Subject: Engine Door Debonding Inspection			
Field change Program: Service Bulletin	Bulletin Number: 3149	Revision: A	Date: 02/10/2021
Coach Section: 03-Body	P/N: 03-31-4155		Type: Service Information

This bulletin outlines steps to inspect engine compartment door de-bonding.

5.0 Replacing shoulder screws

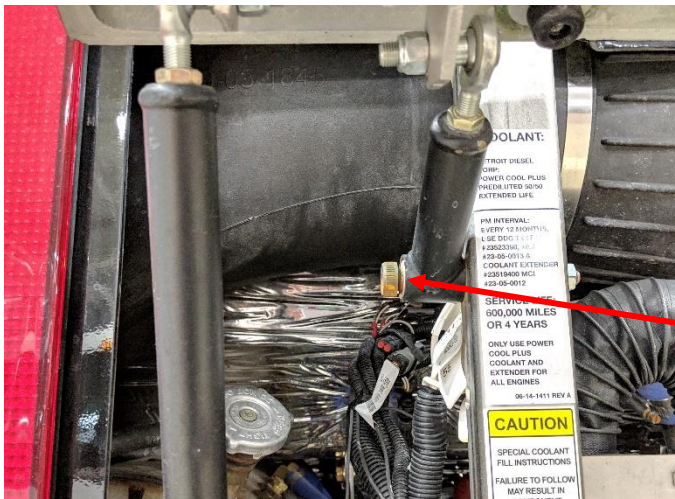
On the driver side, remove the shoulder screw, lock nut bonding short link assembly to the frame tube. Save the lock nut for later use and discard the shoulder screw.

Remove and save the lock nut.
Discard the shoulder screw

Re-install the short link using a new shoulder screw, MCI P/N: 19-01-2385, and existing lock nut. Torque the shoulder screw to 21 FT-LBS.

Re-install short link assembly
using shoulder screw, 19-01-
2385, and existing nut
